5-B-23-HZ
APPLICATION FOR CERTIFICATE OF APPROPRIATENESS

420 E. Oklahoma Ave. 37917
Old North Knoxville H

Staff Report

File Number: 5-B-23-HZ

FRONT ELEVATION
1/8" = 1'-0"

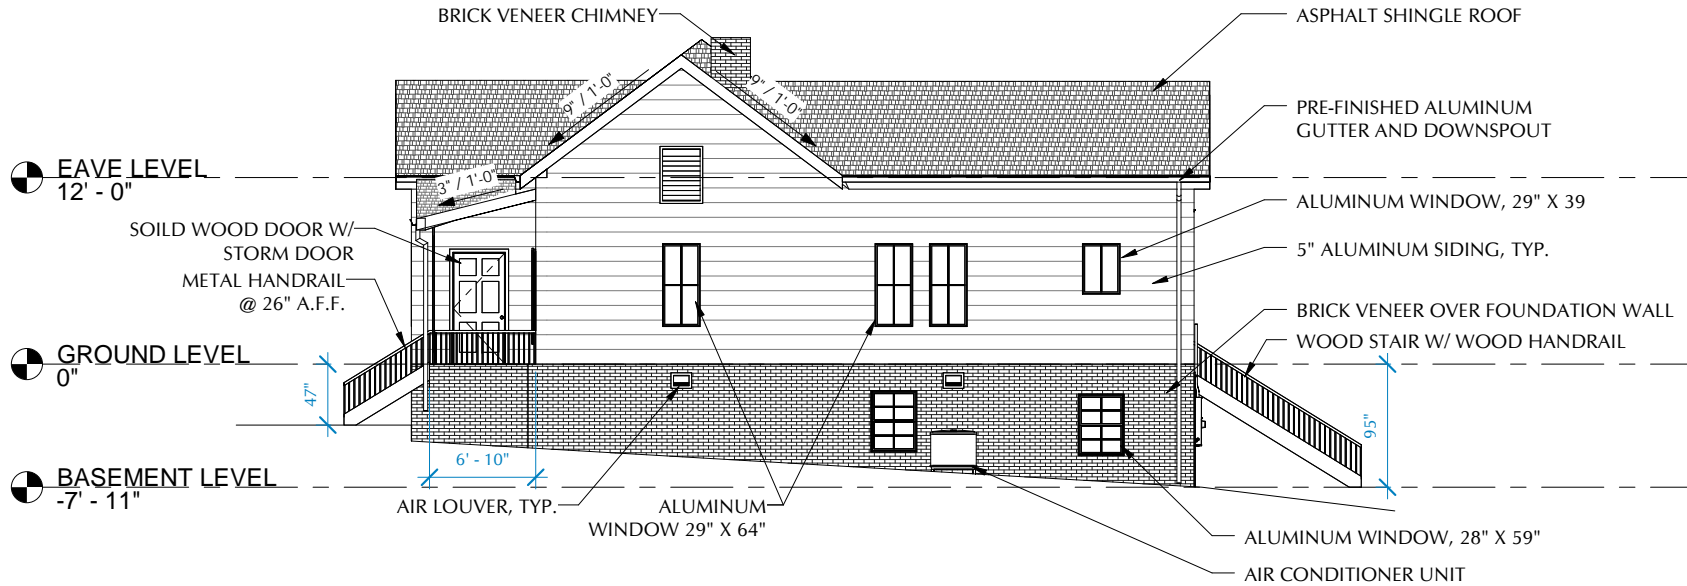
3. Removal of non-historic vinyl shutters and replacement with new wood shutters is appropriate. The new shutters should be operable and reflect the overall size and shape of the windows on which they'll be installed.

5. Removal of second non-historic entry doors have been proposed and approved frequently in Old North Knoxville. The door to be removed is not an original or character-defining feature and not prominently visible from the public right-of-way.

7. Removal of the non-original iron porch detailing and installation of new posts and a balustrade is appropriate within the guidelines. The applicant should provide final specifications, including the selected posts and baluster details with measurements, to staff for approval. Balusters should be set into the top and bottom rails. The posts should reflect those on comparable houses in the neighborhood in size and balustrade may not be required to be 36" by code if the foundation height is under 30" tall.

Staff recommends approval of Certificate 5-B-23-HZ, subject to the following conditions: 1) new shutters to reflect the overall size and shape of the windows, with final specs submitted to staff; 2) applicant to provide further information on existing treatments on brick foundation before applying new paint; 3) applicant to provide a drawing of front porch elements to staff for approval, with new porch elements to be compatible with historic posts and balusters in the neighborhood.

SIDE ELEVATION
1/8" = 1'-0"

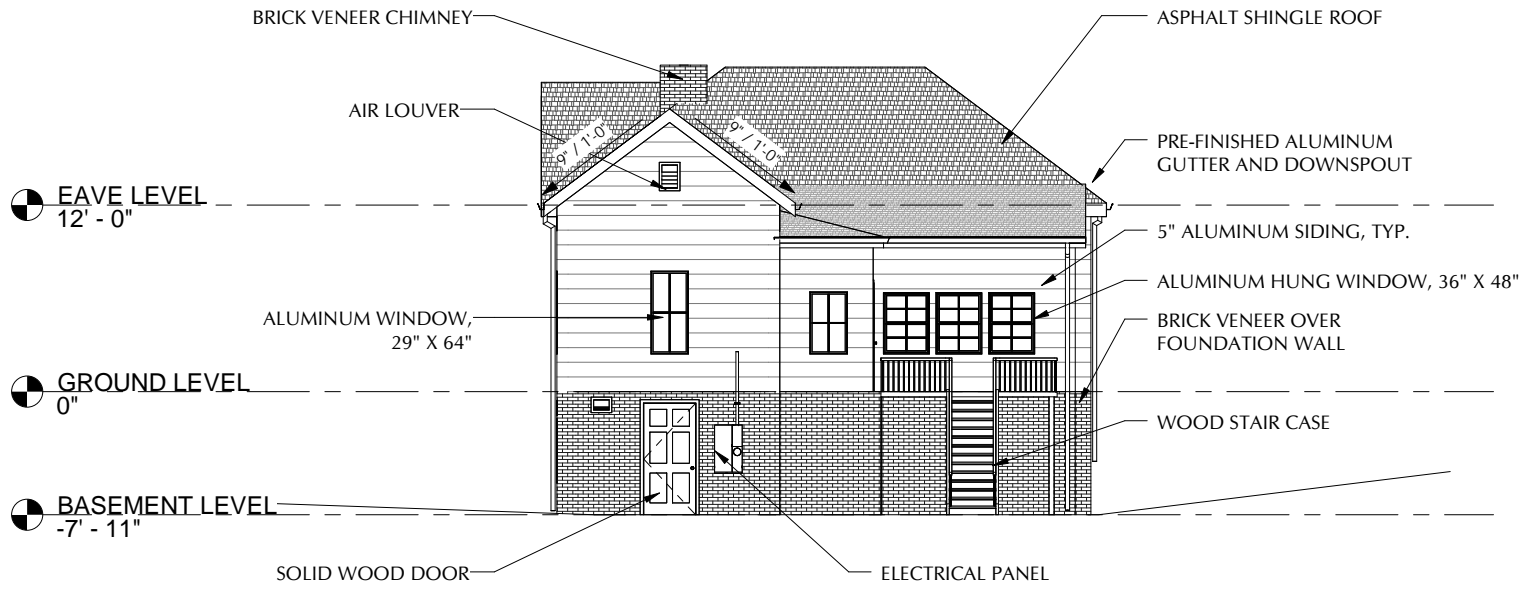
8. Replacement of a non-historic side elevation window with a new window that matches the originals in size and material is appropriate within the guidelines.

REAR ELEVATION
1/8" = 1'-0"

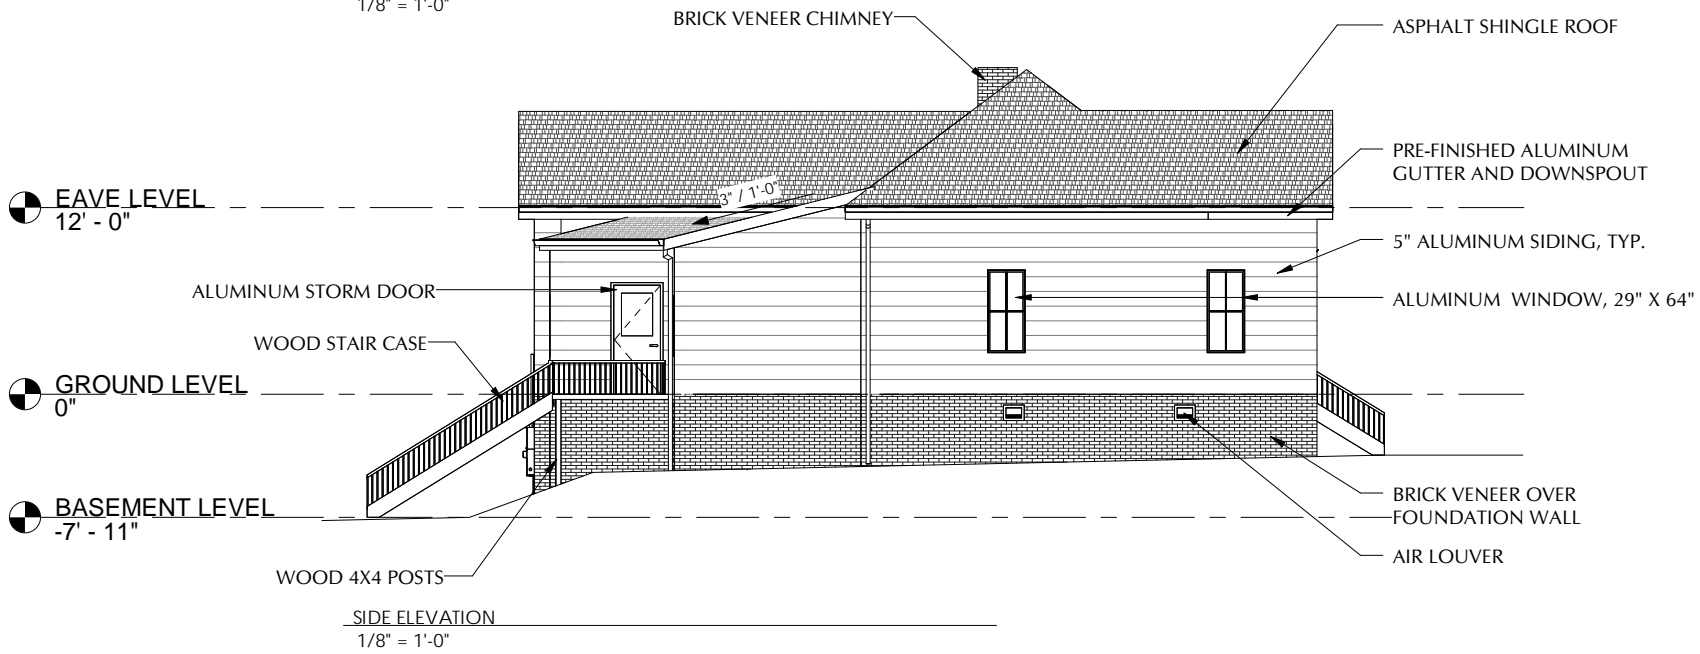
9. The proposed door to be shifted in location is not visible from the right-of-way and will retain the original or existing door. Shifting the door will not require the removal or alteration of any historic features.
